Buffalo River Watershed Alliance

Comments on C&H Reg 5 Permit Application

FIGURE 1 EXAMPLE OF A FIELD 21A, WHICH IS CONTORTED AND INAPPROPRIATE FOR WASTE APPLICATION

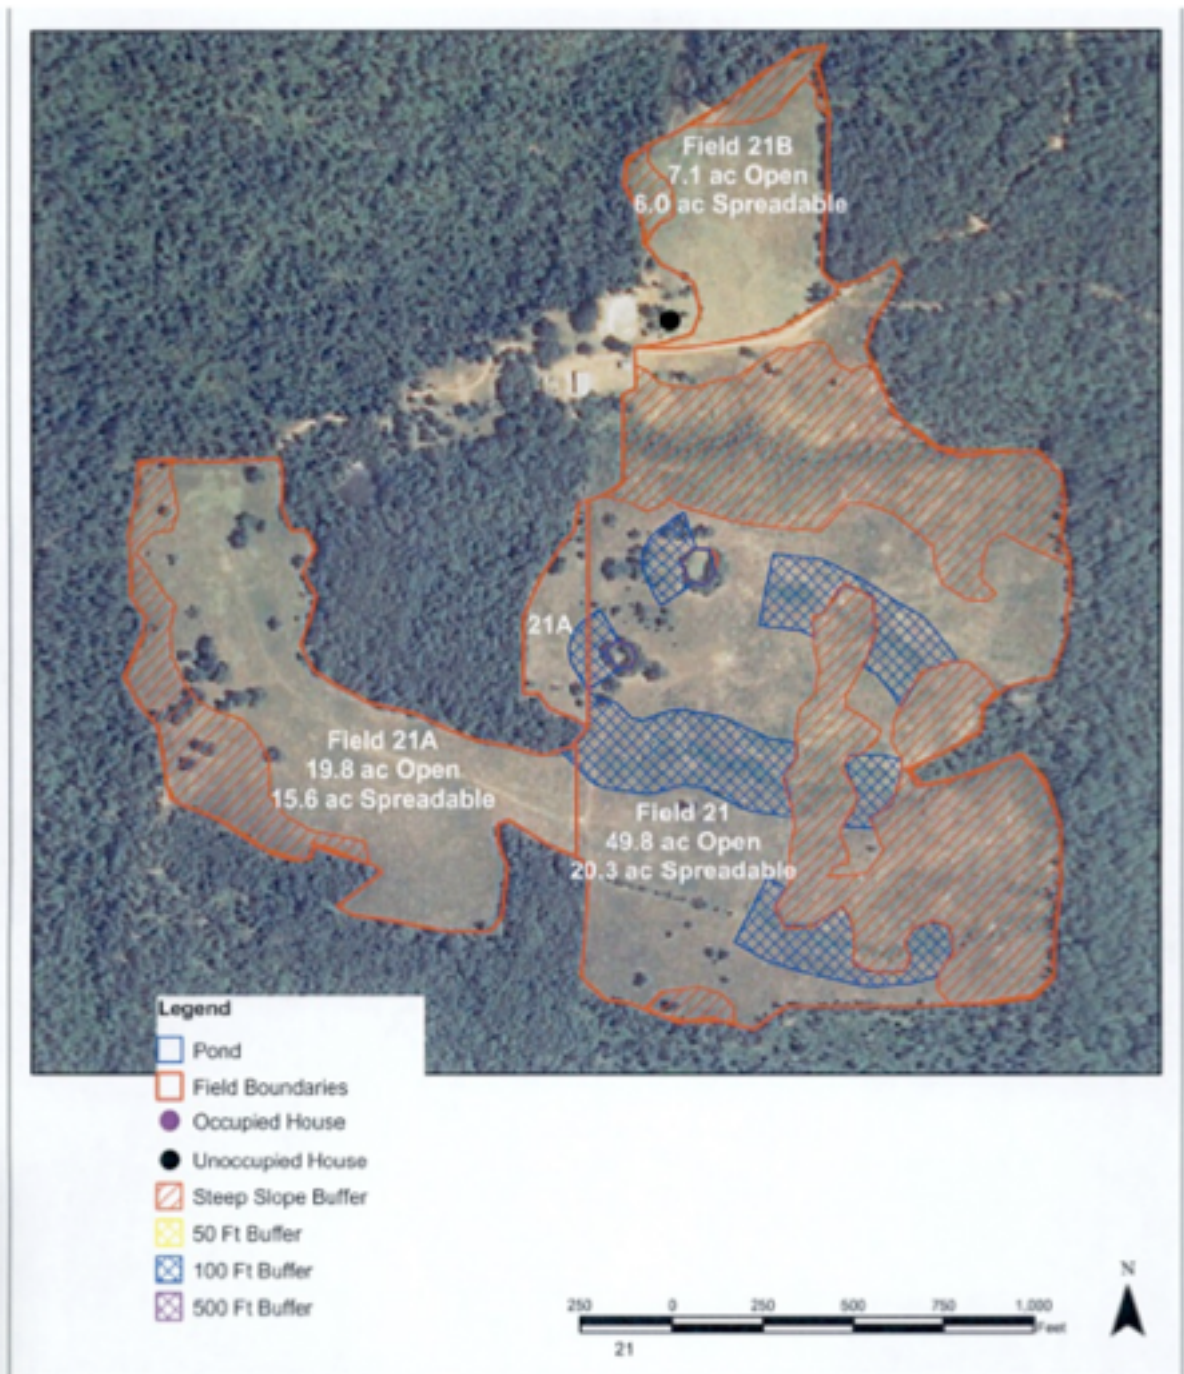
Comment B10 - This permit should be denied because of the extreme difficulty of complying with the application buffer zones and because compliance is impractical to monitor or enforce

Many of the fields, particularly the upland ones, include buffer zones which are so fractured, convoluted and circuitous that the chances of applying waste outside the buffer areas are very high. Many of the fields, such as fields 13, 15, 16, and 21, are broken into multiple segments by the buffer zones. Fields 1, 2, 4, 6, 8, 10, 13, 14, 15, 19, 20, 21, 22, and 35 include multiple 50 and 100-foot buffers and some 500 foot buffers to avoid adjacent streams, drainage areas, ponds, steep slopes, rock outcroppings as well as adjacent homes and property lines. Flagging or other marking has not been observed demarcating any exclusion zones and, even if proper flagging was present, the logistics of navigating and applying swine waste from “honey wagons” to these fields is difficult at best and the risk of applying waste inside the buffer zones is

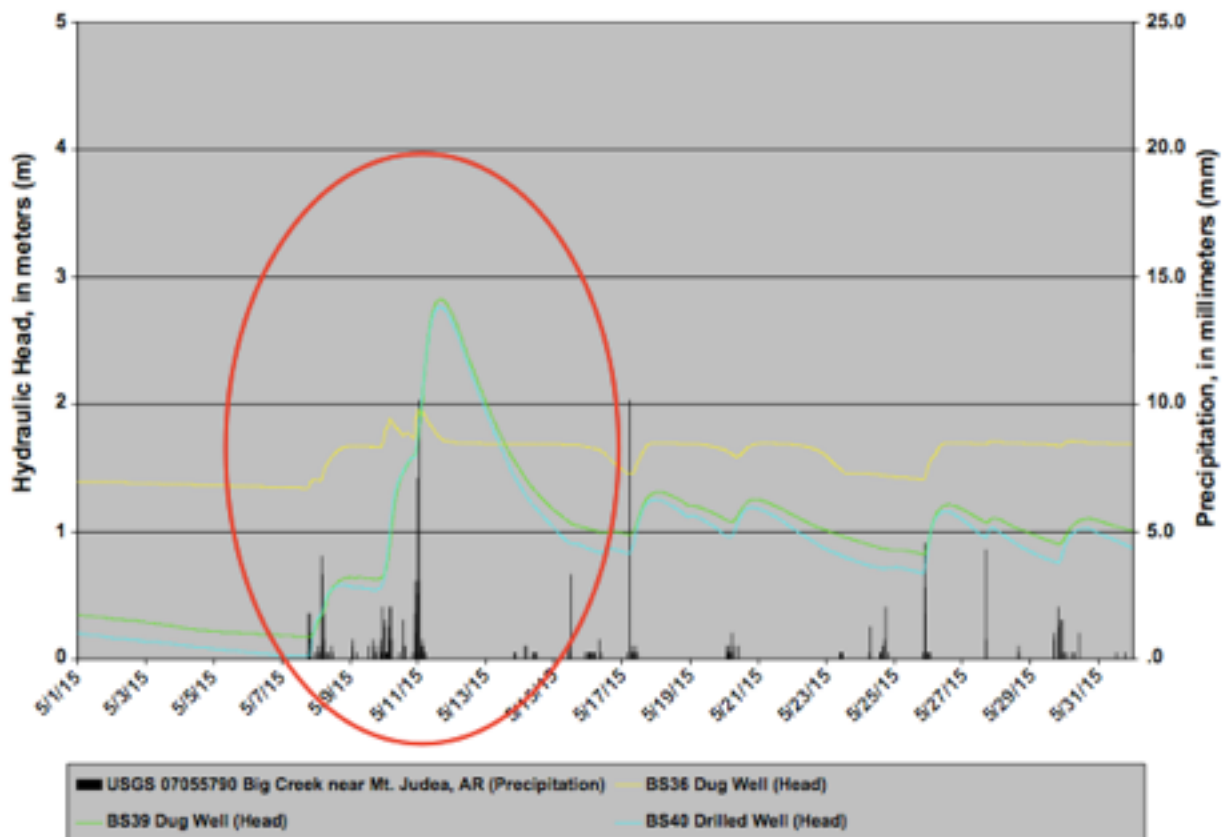
“For the groundwater wells, time lag was essentially identical to the time lag of the surface- water stage, indicating that groundwater levels started rising no later than an hour after precipitation started. Rapid response of the groundwater level is an indicator that karst conditions facilitate rapid flow of precipitation into the ground. The magnitude of the water-level increases can be caused by several factors including: variation of permeability or porosity of the aquifer materials; variation in storage as the groundwater moves downgradient, variations in the epikarst (upper eroded zone) at the top of the Boone (BS-39); and variations in Big Creek alluvium and terrace deposits (BS-40) that directly overlie the Boone in Big Creek Valley (Braden and Ausbrooks 2003).”

Appendix C3 - Review of permeability determination

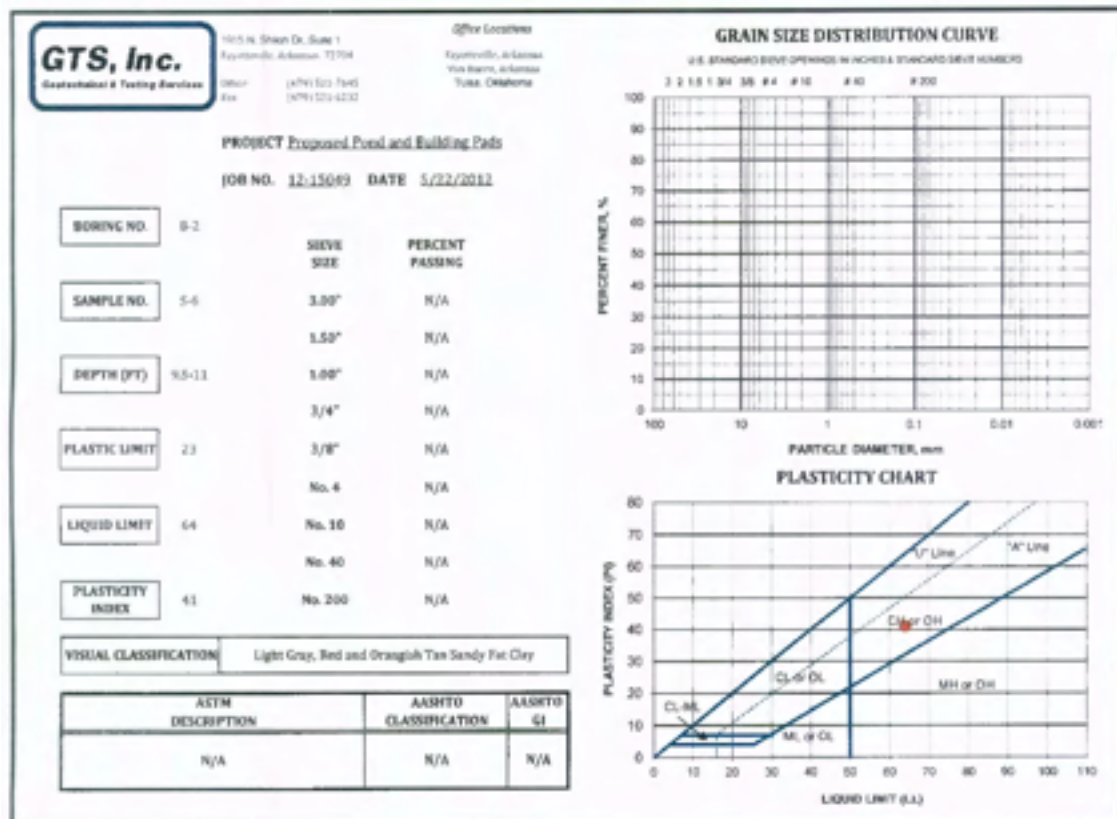
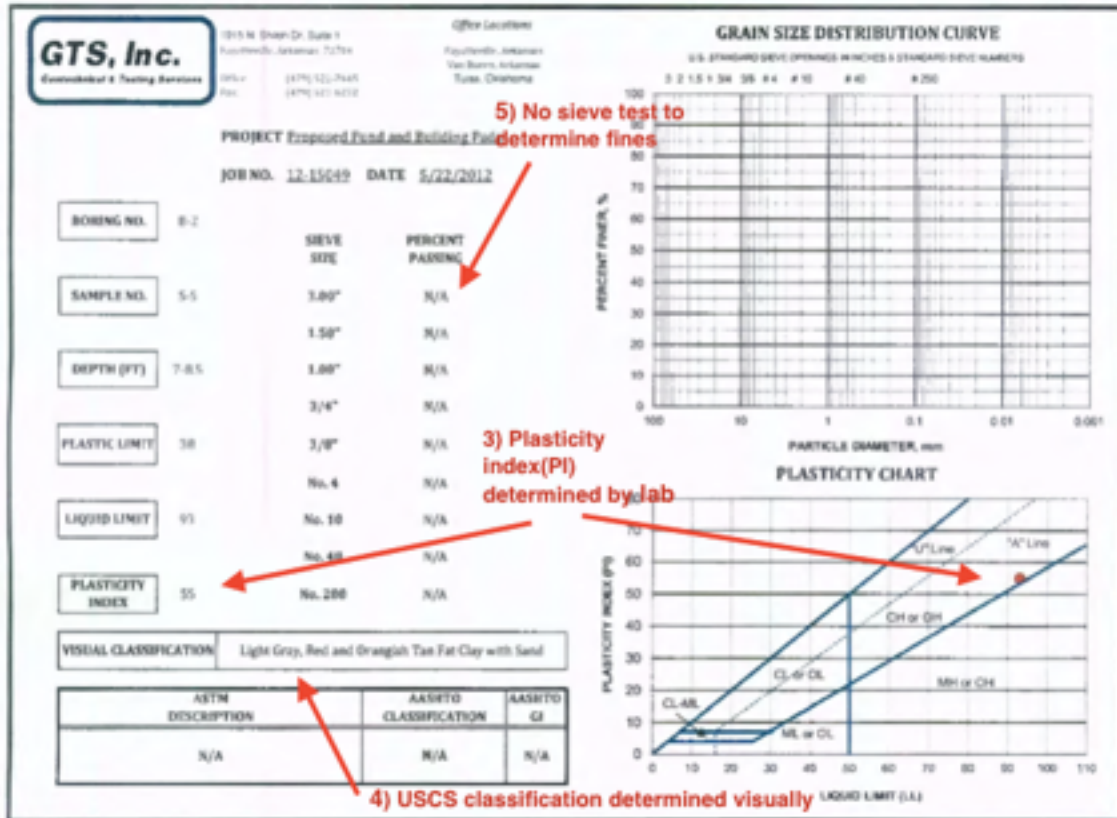
To recap, point #1 is the particle analysis of the soil determining percent of “fines”. Point #2 is the *plasticity index* (PI). To review some of the testing documents in the original NOI, reference Appendix C3. The information in Appendix C3 looks at the geologic soil testing process in the original NOI that resulted from drilling 3 holes: B1, B2, B3. Only B2 and B3 are in proximity to the ponds so only these samples are used to evaluate liner material (see Appendix C6). Note that the number of holes drilled does not conform to AWMFH guidelines (discussed in Comment C6).

Appendix C6 - Original NOI bore holes

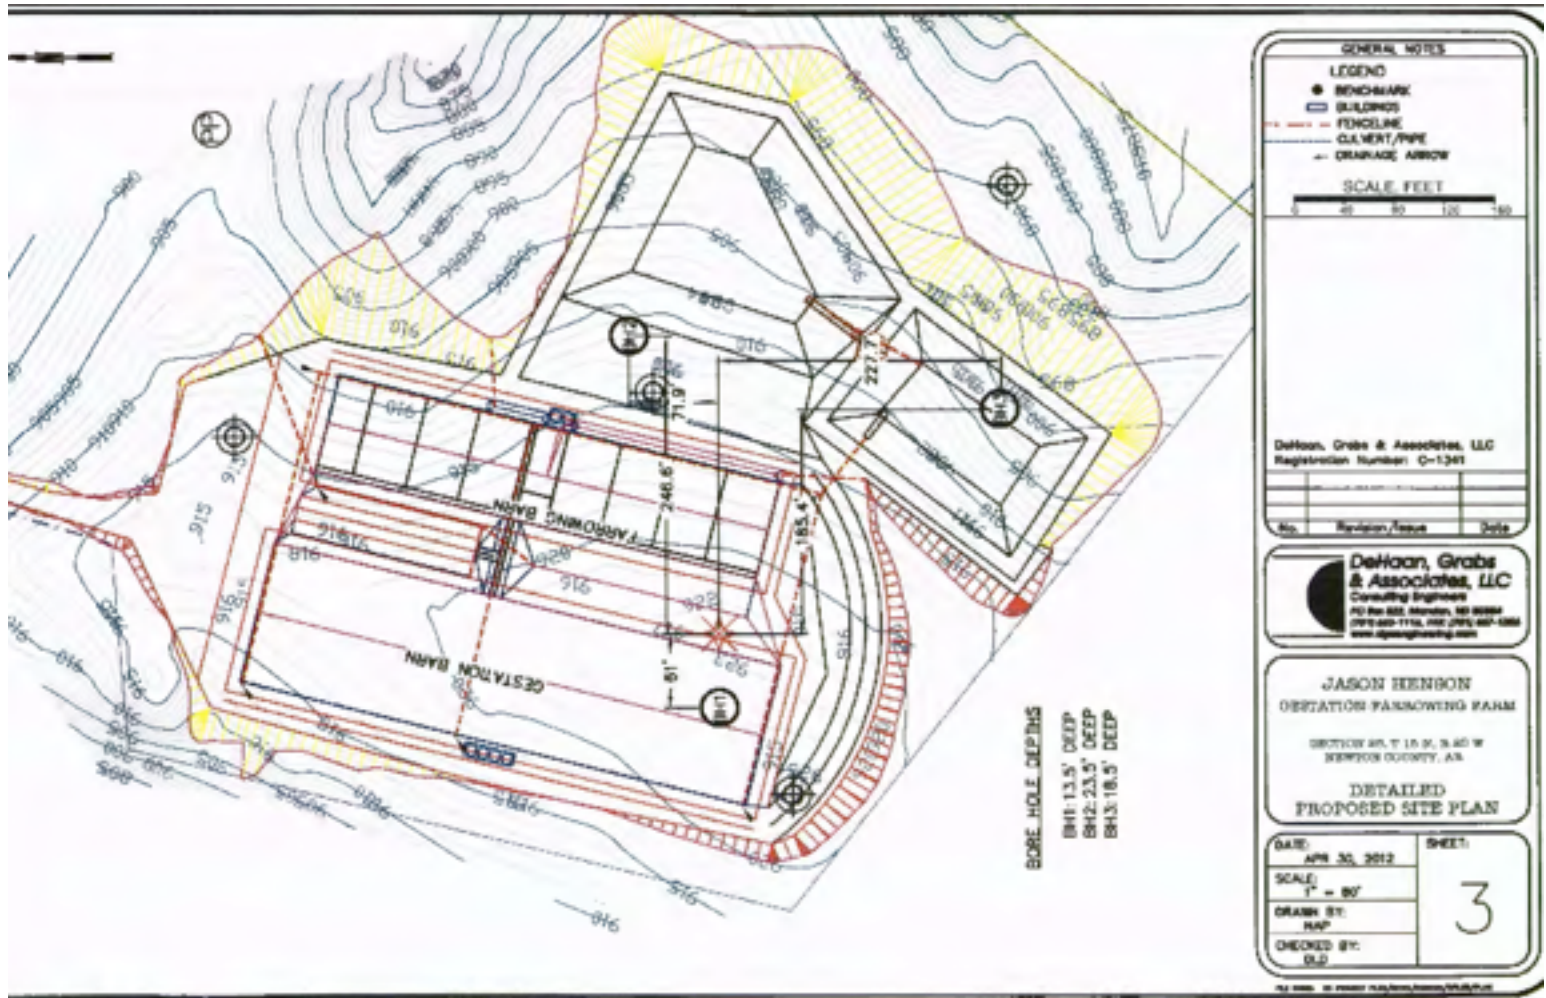
Comment C6 - This permit should be denied because the pond subsurface investigation does not conform to AWMFH guidance

“The subsurface investigation for earthen holding ponds and treatment lagoons suitability and liner requirements may consist of auger holes, dozer pits, or backhoe pits that should extend to at least two (2) feet below the planned bottom of the excavation.”

Appendix C12 - Determination of Elevations Page 1 of 2

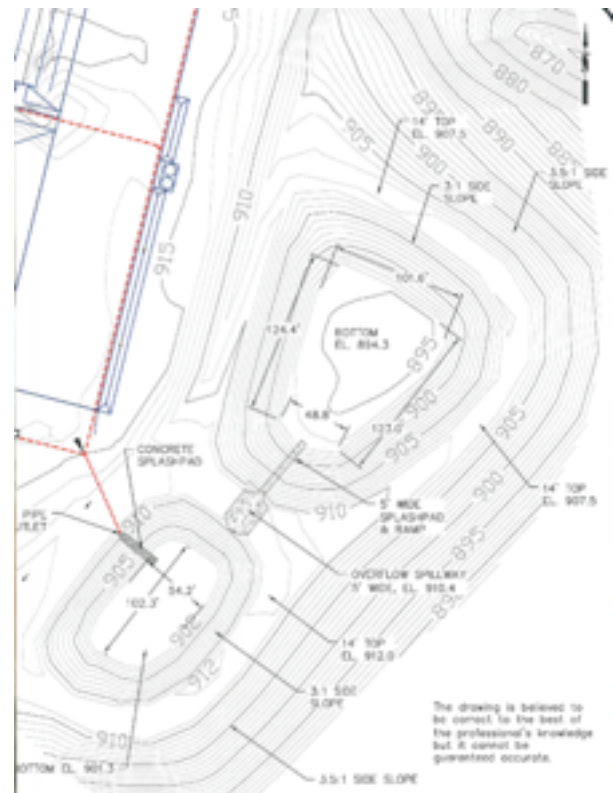
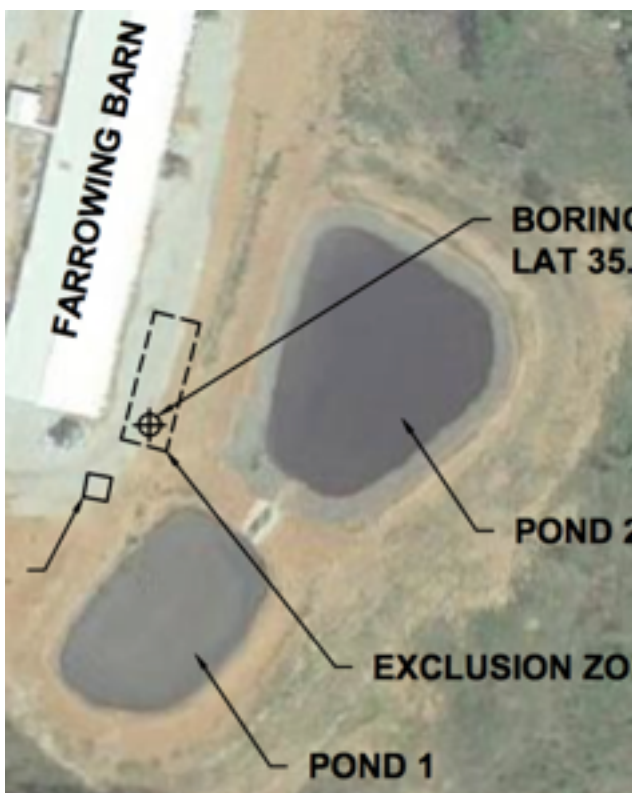
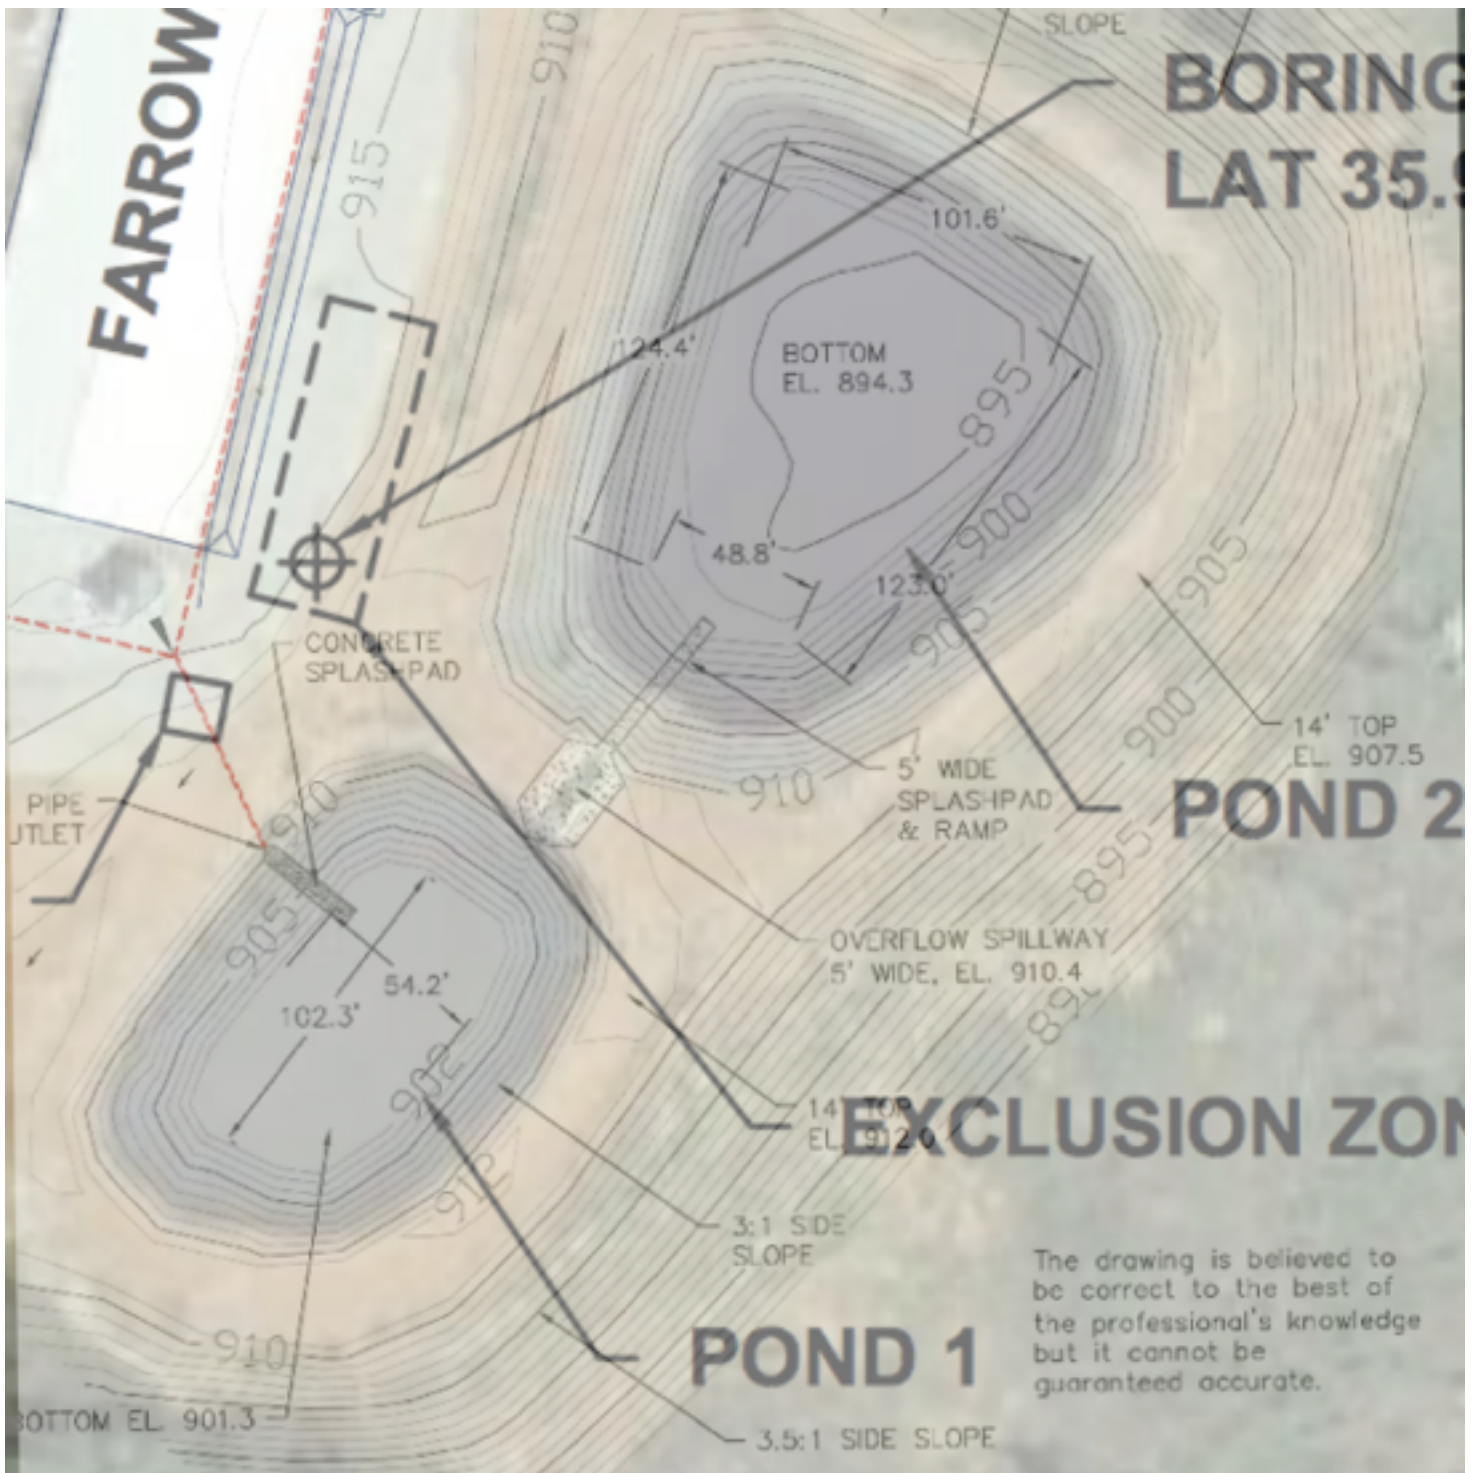
Harbor Environmental submitted a work-plan in August of 2016 for drilling a single bore hole to investigate Dr. Todd Halihan’s west transect (Oklahoma State ERI study). Although Harbor Environmental provided geographical coordinates for the planned hole, they failed to provide an elevation. As a result, Harbor later submitted an addendum on Jan 9th, 2017 with an elevation of the bore hole certified by licensed professional surveyor Johnny R. Tweedle. The original “as built” engineering plans also show the elevation of the bore hole (see Appendix C12). These “as built” plans were certified by licensed professional engineer Nathana Pesta on April 5th 2013. Mr. Tweedle’s certified elevation is higher than Mr. Pesta’s certified elevation by 16.31 feet. We are unable to identify any nearby elevations at the facility that are at the height that Mr. Tweedle states.

Several of the comments below discuss elevations of the bore hole relative to the pond floors and are based on the “as built” elevations. The “as built” drawings are a term of the permit and are required to show accurate contouring and relative depths. The “as built” drawings agree with relative depths described in the permit narrative and are the best and only source that is provided for examining relative elevations.
